**IN RE BNSF RAILWAY COMPANY**

**PETITION FOR EXEMPTION FROM COMPLIANCE**

**DOT DMS DOCKET No. FRA-2003-15432**

**TESTIMONY OF**

**Chart 1. Month to Month Comparison**

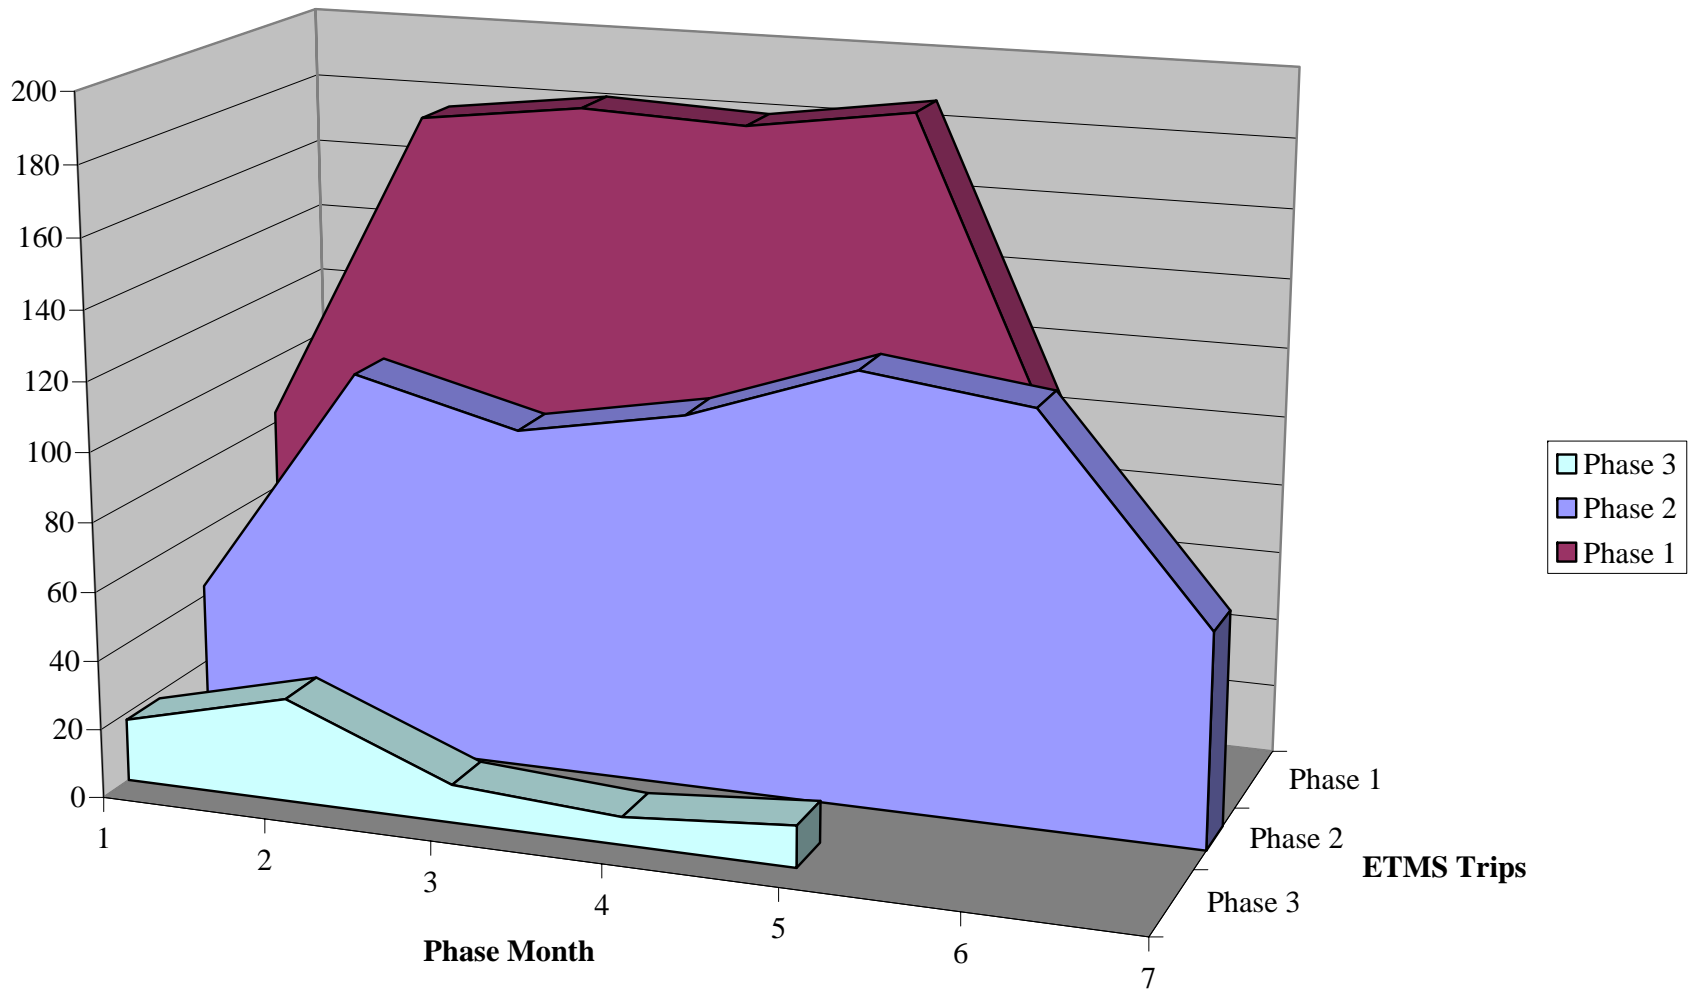
Chart 1, which is attached to the written submission of our testimony, shows a month-by-month comparison of the number of ETMS trips across each of the three phases. It clearly demonstrates that there has been a vast reduction in the number of trips per month during Phase 3, as compared to the earlier phases.

The dramatic decline — both in the number of trips (the quantity of testing) and in median trip length (the quality of testing) — should give FRA pause in considering BNSF's petition. Not only did the number of Phase 1 trips exceed by one-third the number prescribed for minimum satisfaction of the Phase 1 conditions, Phase 3 has proceeded at a snail's pace. While no clear cause for this significant change is apparent from the publicly available data, we submit that the record does not support a conclusion that the Beardstown waiver conditions provide an appropriate basis for assessing ETMS safety and reliability; much less that ETMS has satisfied those conditions.
